**To: All Vendors Bidding on The College of New Jersey
STEM MEP Modifications Project**

ADDENDUM NO. 1

REFERENCE: The College of New Jersey
STEM MEP Modifications Project
Bid No. AB190029

1 STEM Building Chilled Water System Control Diagram
 M705/ NO SCALE

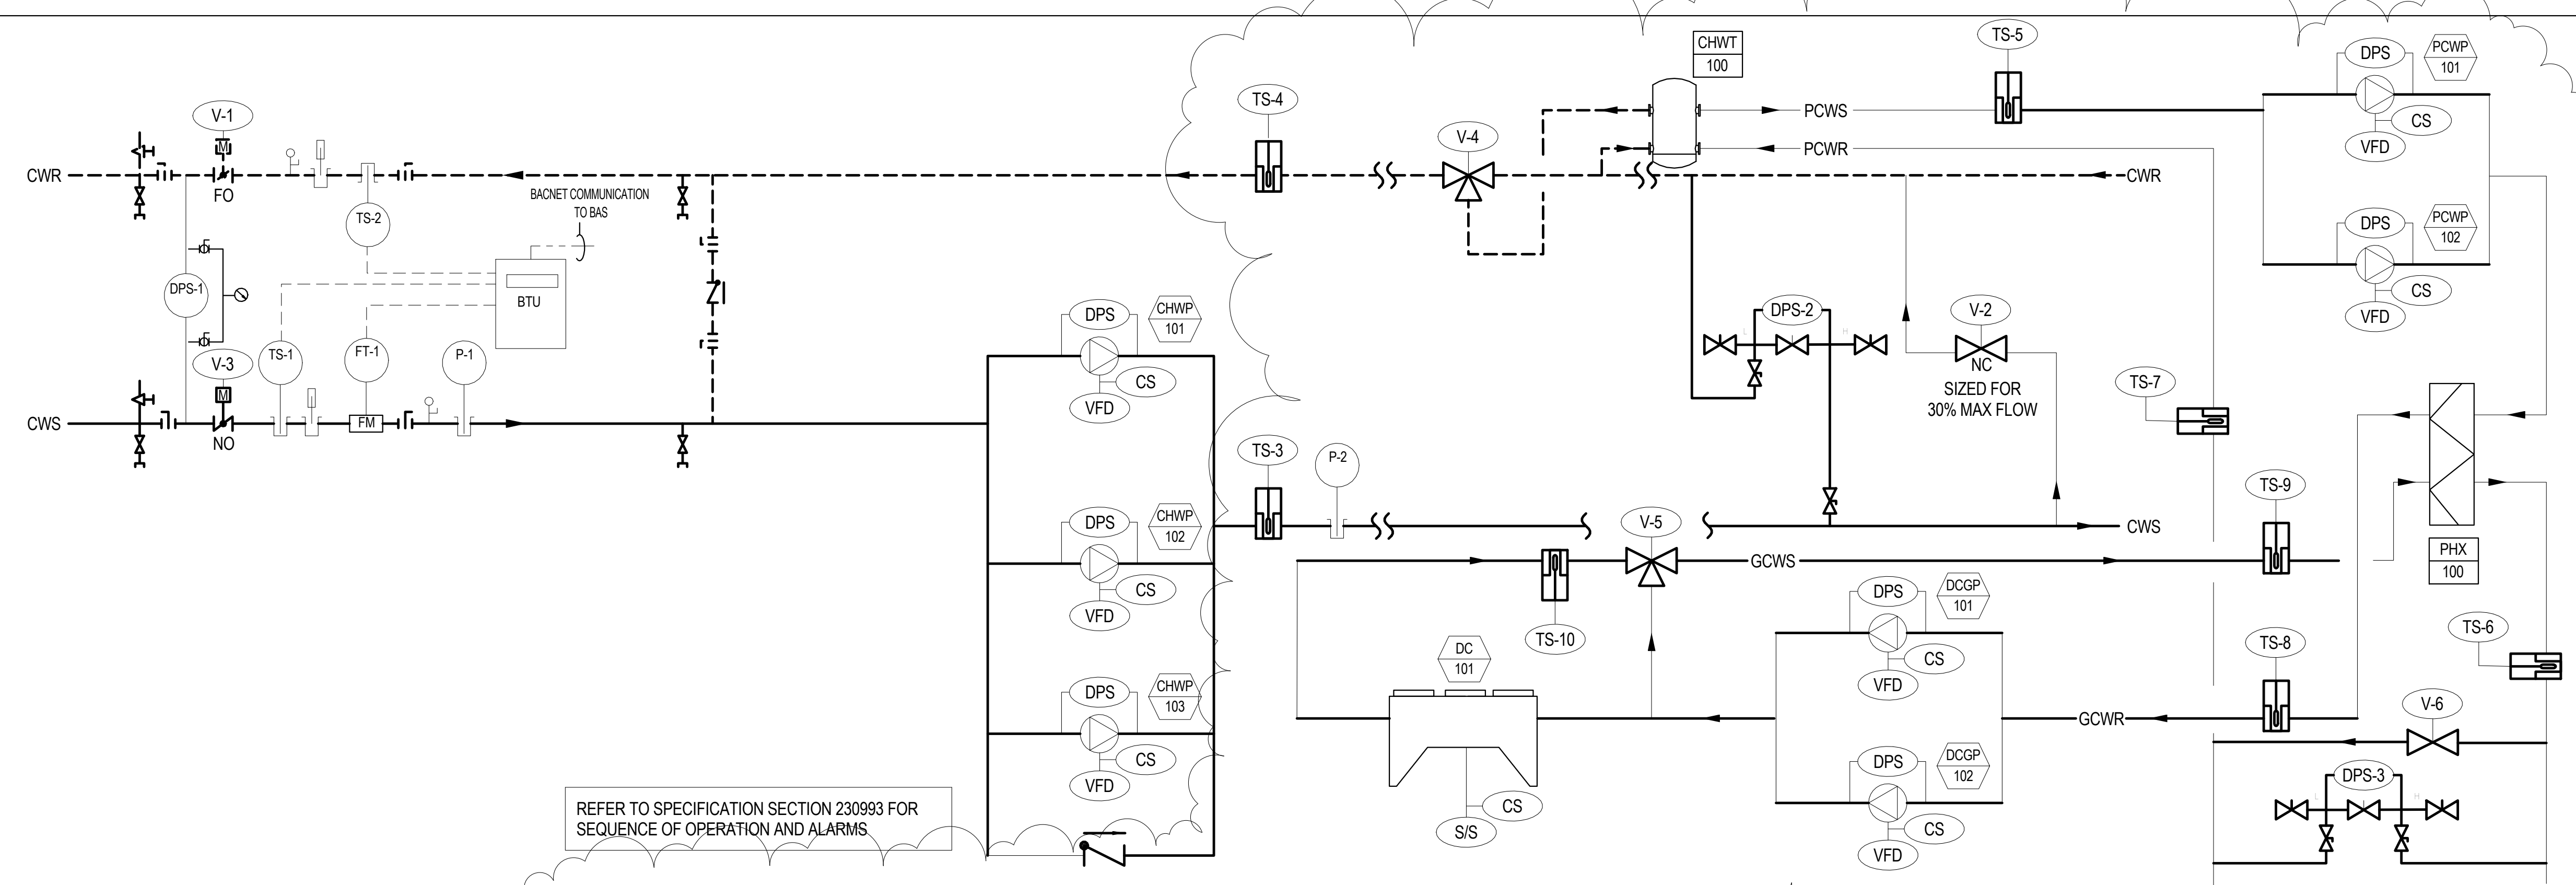
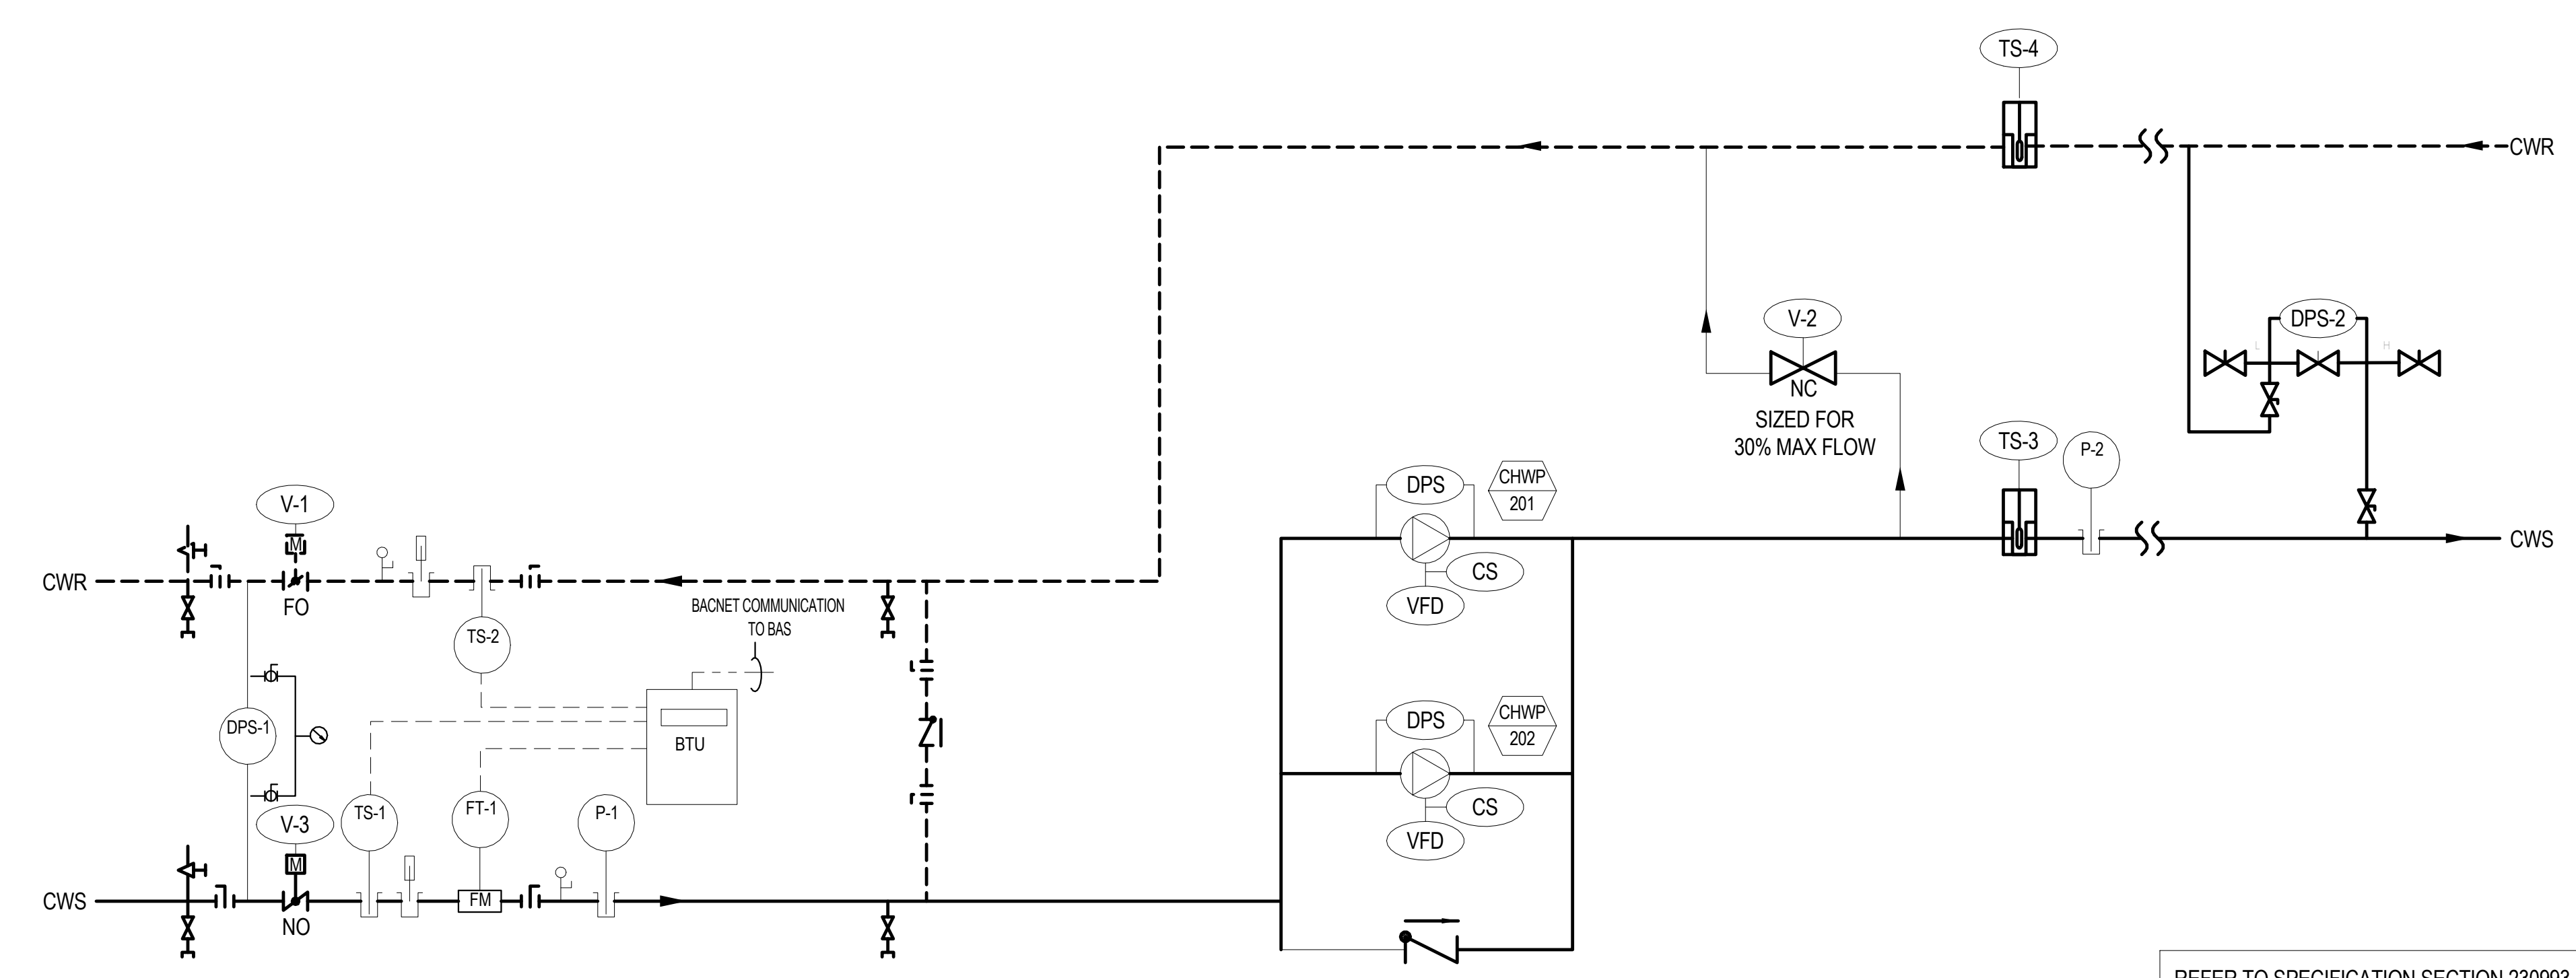
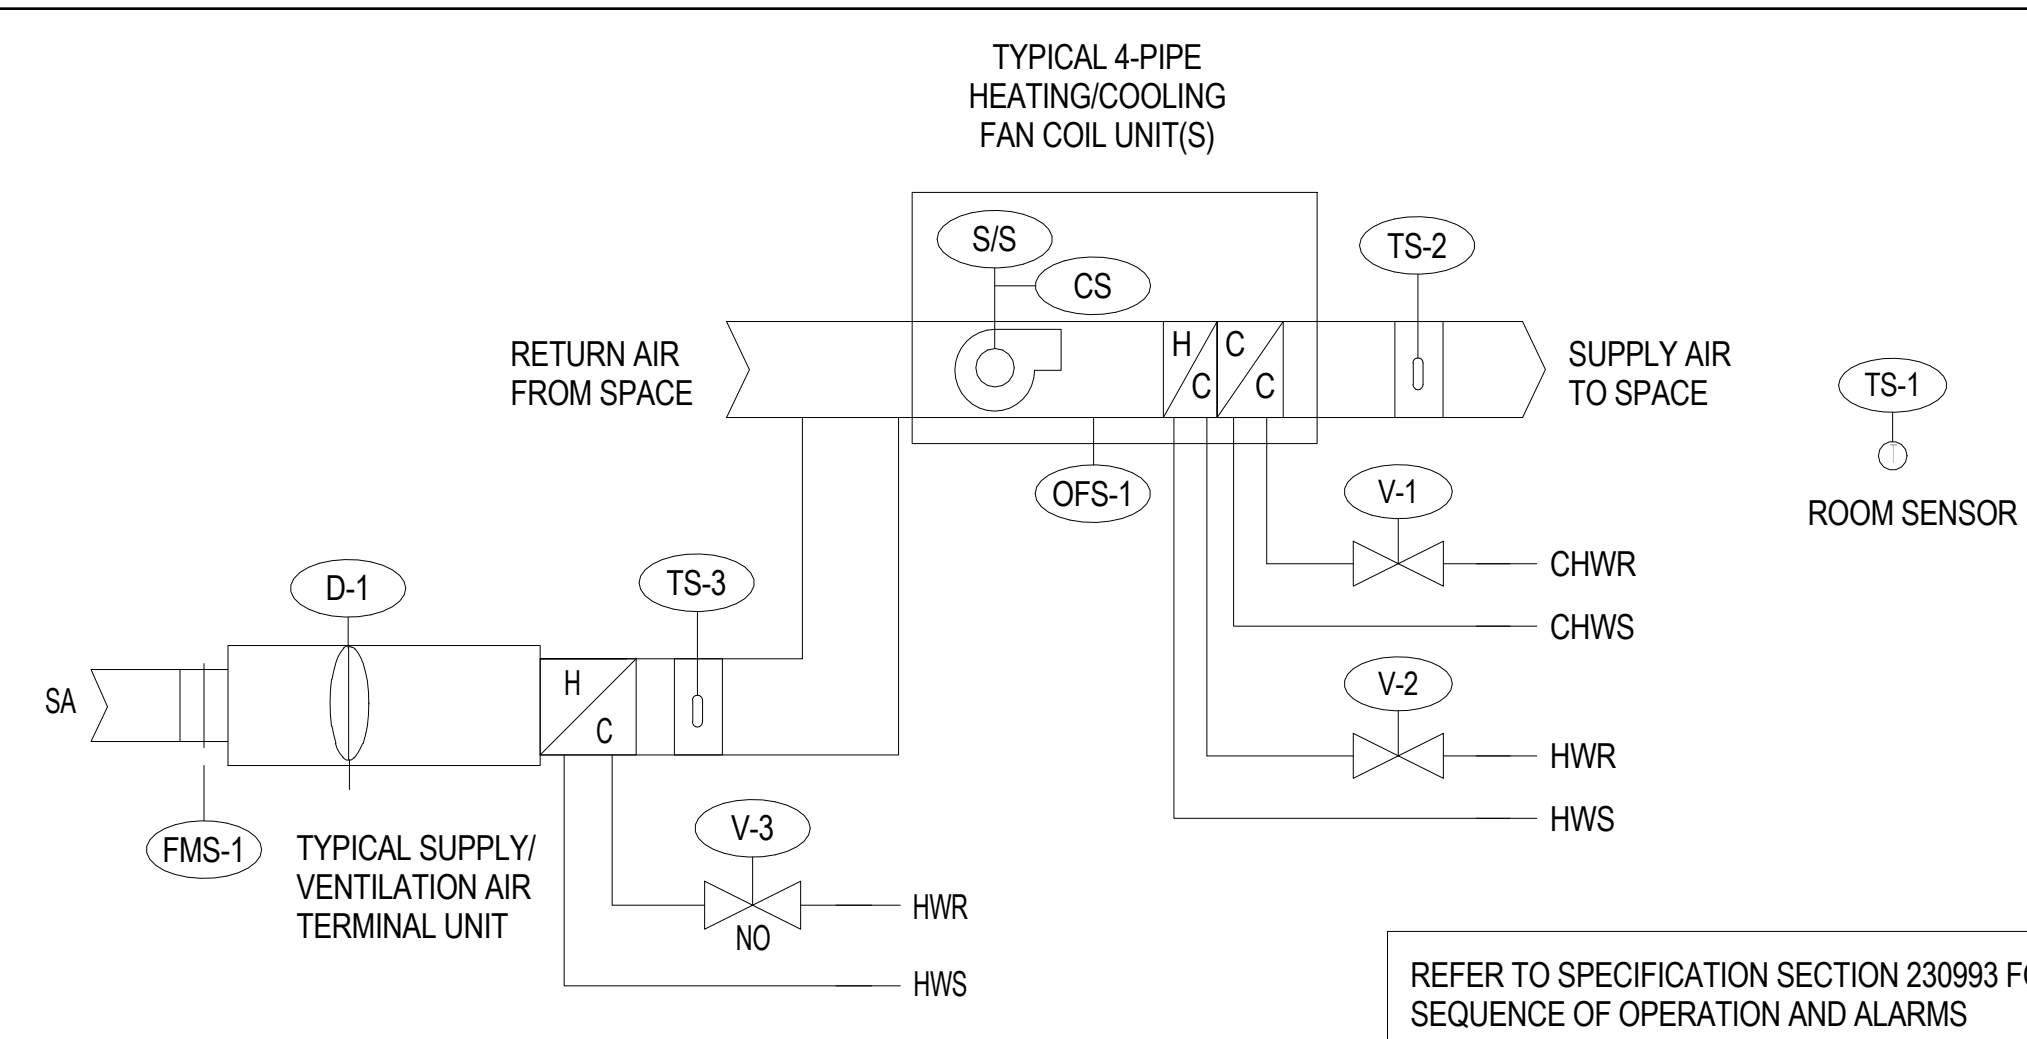
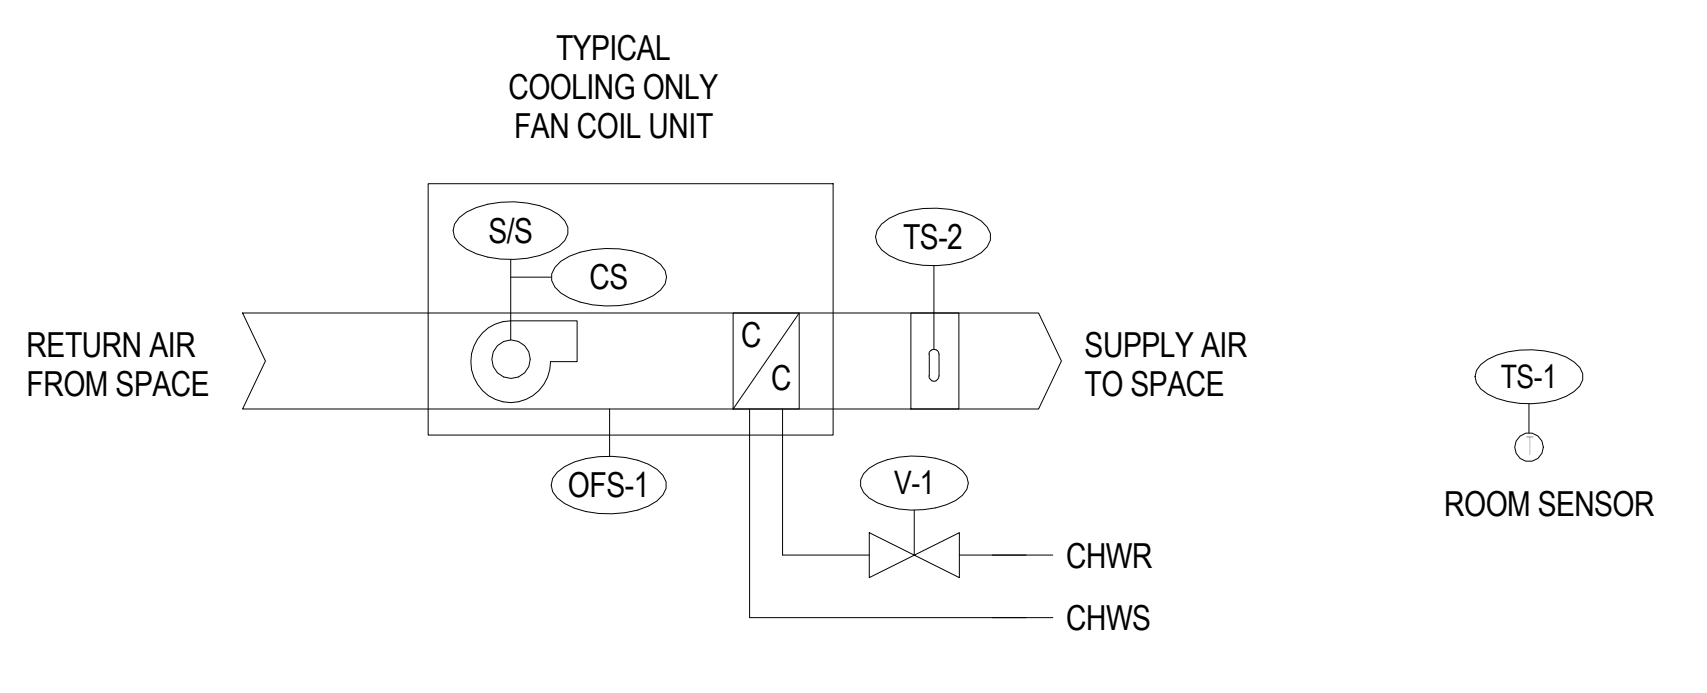
7. Bulletin #28 refers to drawing M705. There is no drawing M705 in bid package?

Answer: See attached sheet M705.
